AMENDMENTS TO THE DRAWINGS

REMARKS

ANNOTATED SHEET SHOWING CHANGES MADE

Figure 2

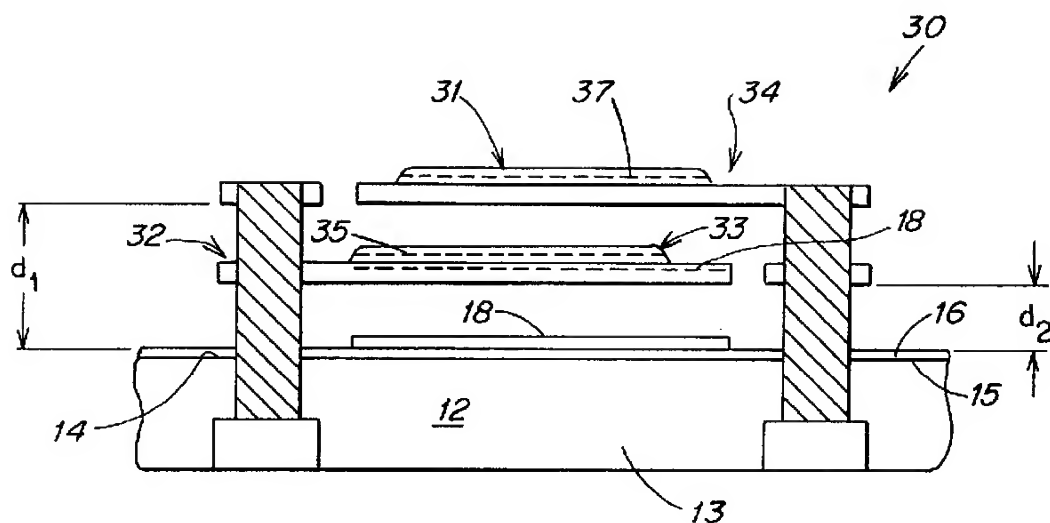
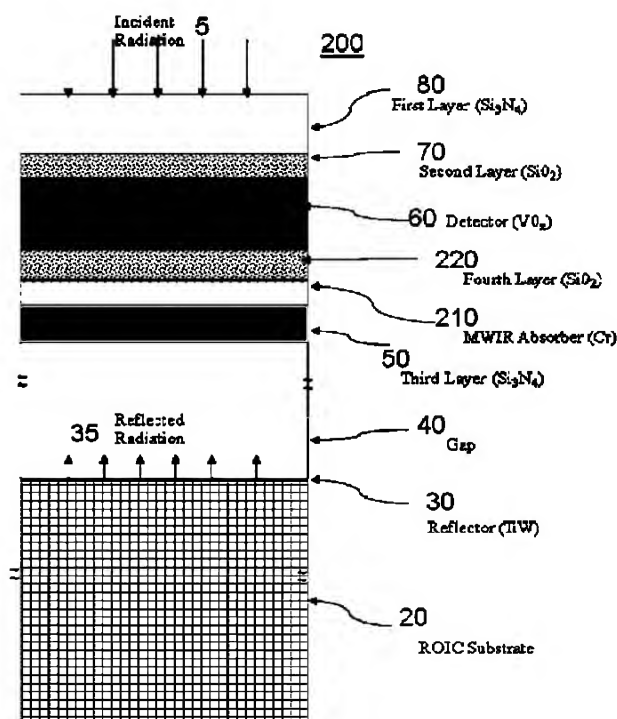
Independent claims 1, 6, and 13 have been amended to include "a single microbridge level" supported, at least, in Figures 2, 9, and 12 and paragraph 22 of the present application. Marshall et al use two independent microbridges to achieve dual band operation. The present application uses a single microbridge that is sensitive to dual bands. Sensing dual (or more) bands in a single microbridge is not the same as sensing dual bands in two independent microbridges. No new matter has been added.

Figure 2 of Marshall et al .and Applicant's Figure 2 are included below to illustrate this distinction.

Marshall et al FIG. 2 showing a first microbridge level 32 and a second microbridge level 34.

Applicant FIG. 2 showing a single microbridge level with a single gap 40.

Marshall et al in describing the embodiment of Figure 2 specifies in column 5, lines 52-55 and subsequently that feature **32** is a first microbridge level and feature **34** is a second microbridge level. Applicant's embodiment of Figure 2 depicts a single microbridge level with a single gap **40**.

Figure 3

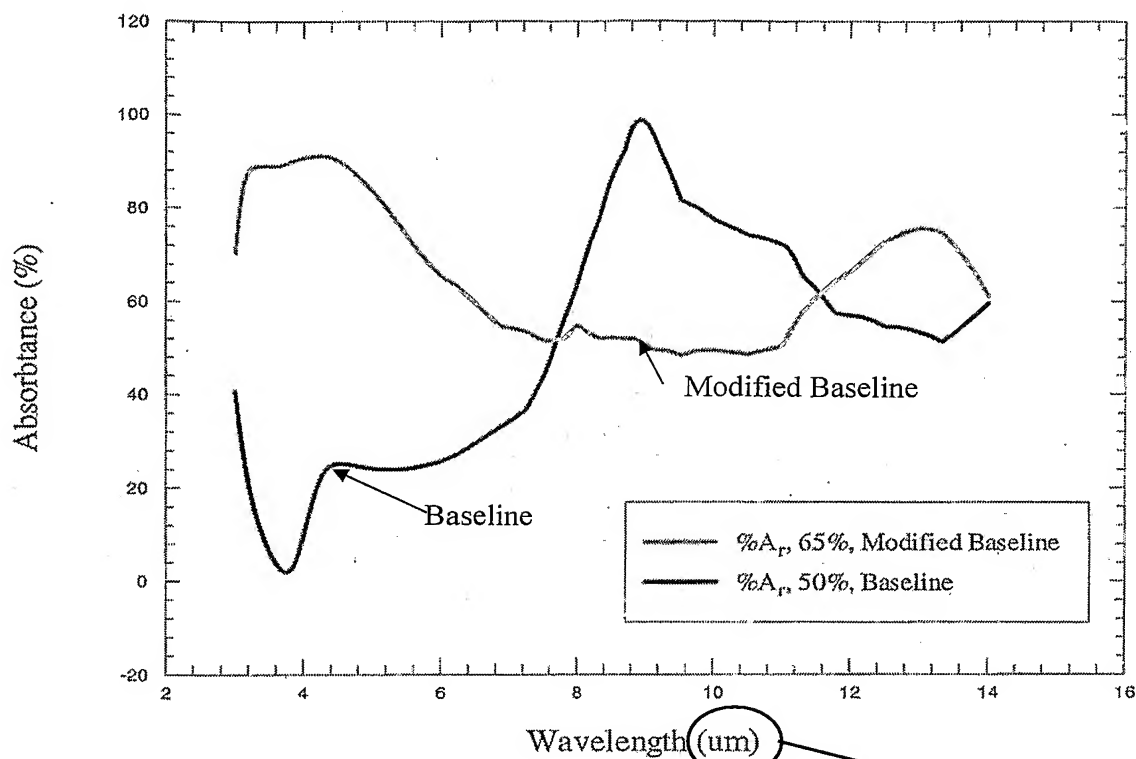
The attached 8 sheets of drawings include changes to Figures 3, 4, 5, 6, 8, 10a, 10b, 10c, 10d, and 11. These sheets, which include Figures 3, 4, 5, 6, 8, 10a, 10b, 10c, 10d, and 11 replace the original sheets including Figures 3, 4, 5, 6, 8, 10a, 10b, 10c, 10d, and 11. In Figures 3, 4, 5, 6, 8, 10a, 10b, 10c, 10d, and 11, the use of "um" where μm is called for has been corrected by replacing "um" with " μm ". No new matter is added.

The Office in paragraph 2 objected to drawings because of the use of "um" where μm is called for. Corrected drawing sheets 3-5 and 7-11 for Figures 3, 4, 5, 6, 8, 10a, 10b, 10c, 10d, and 11 in compliance with 37 CFR 1.121 (d) are provided to overcome the objections. No new matter is added.

Figure 5

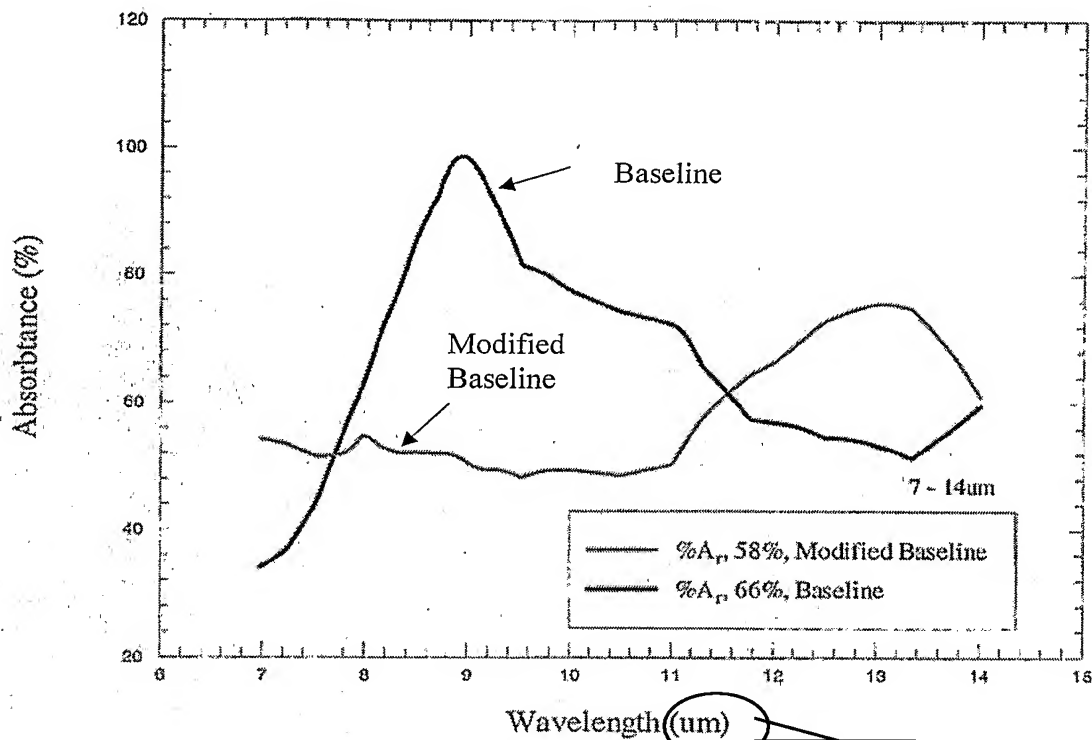
Changed to um

Figure 6

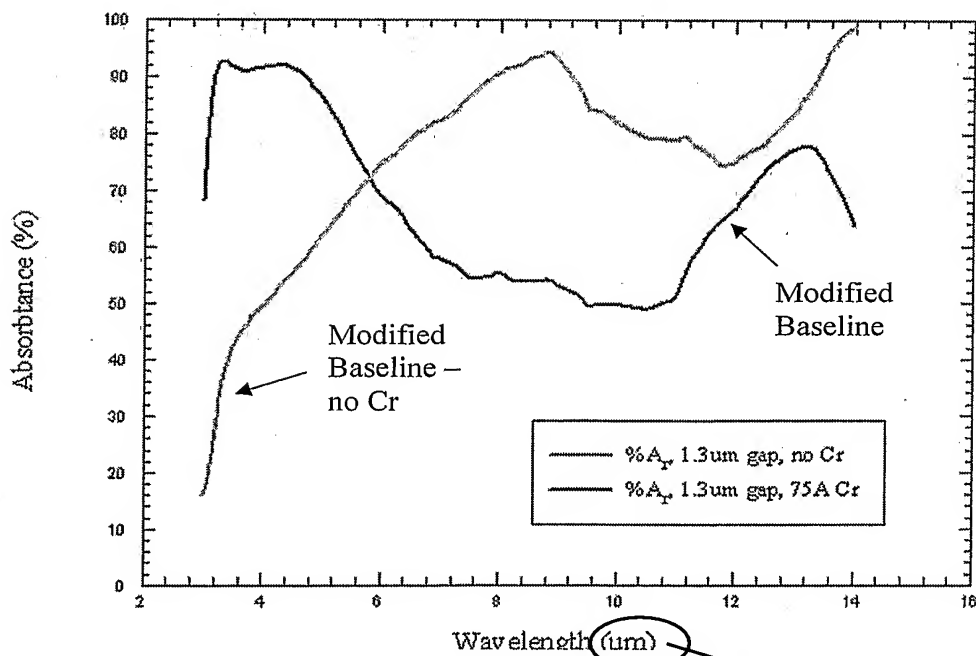
Changed to um

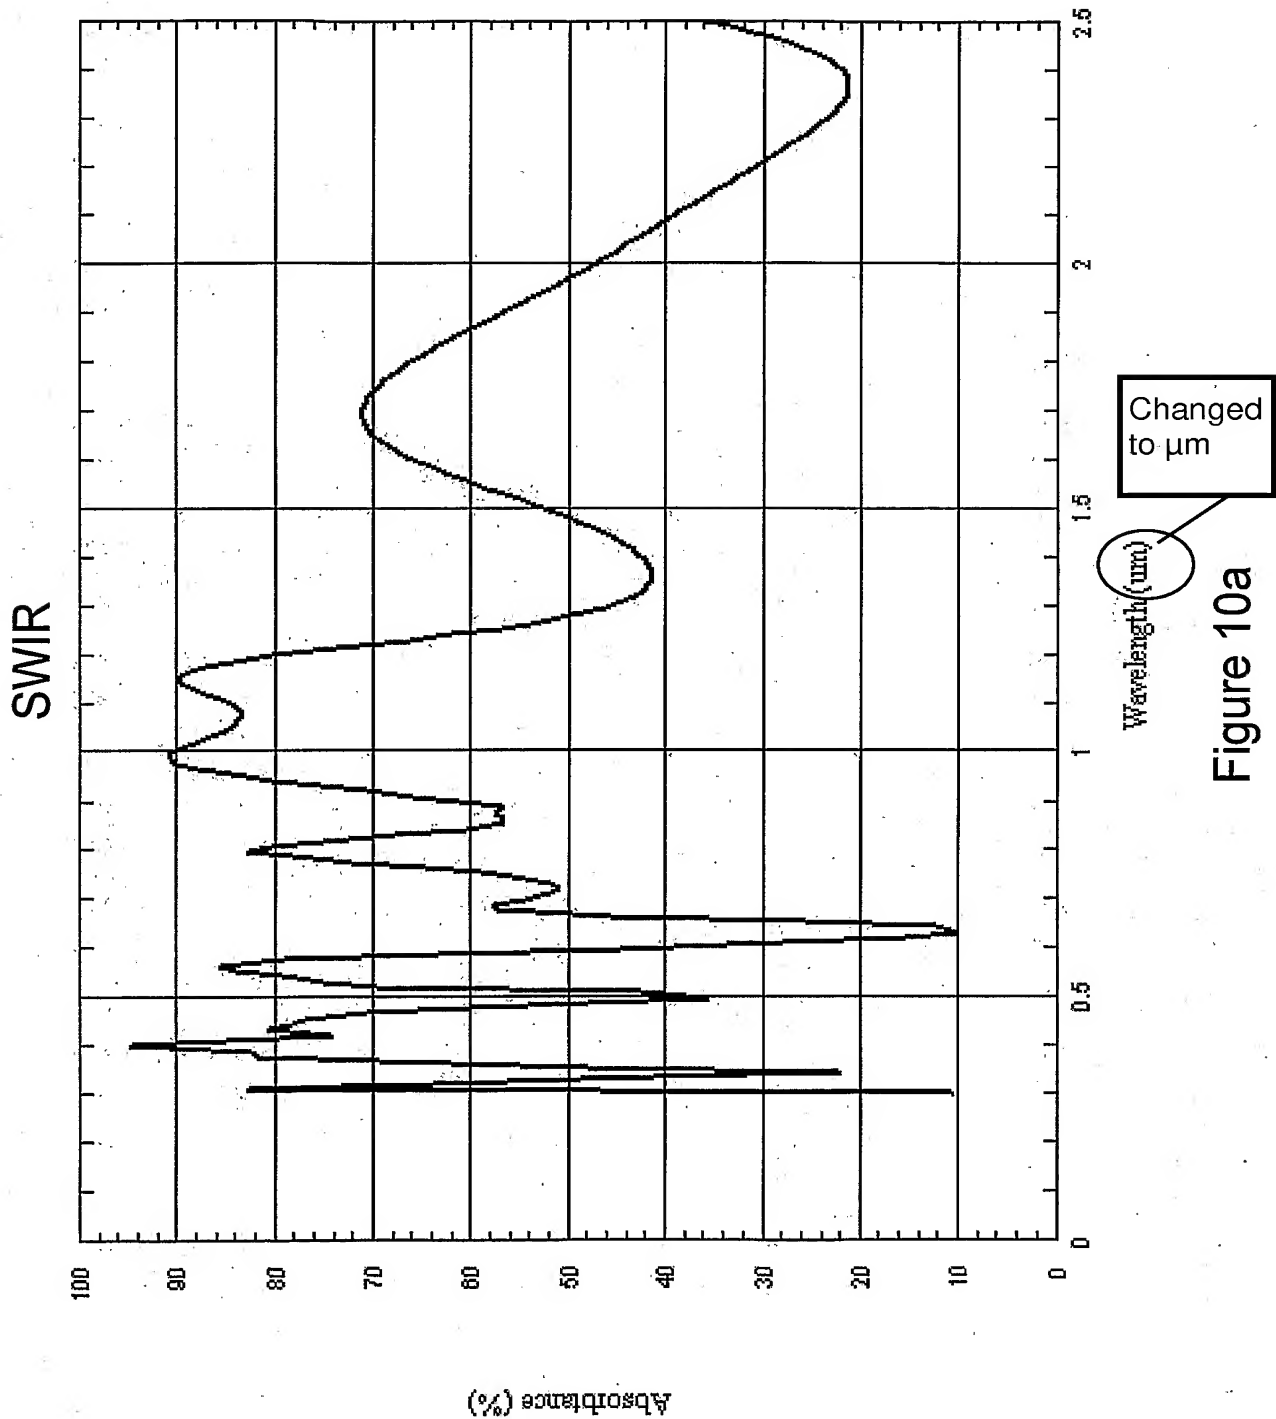
Changed to μm
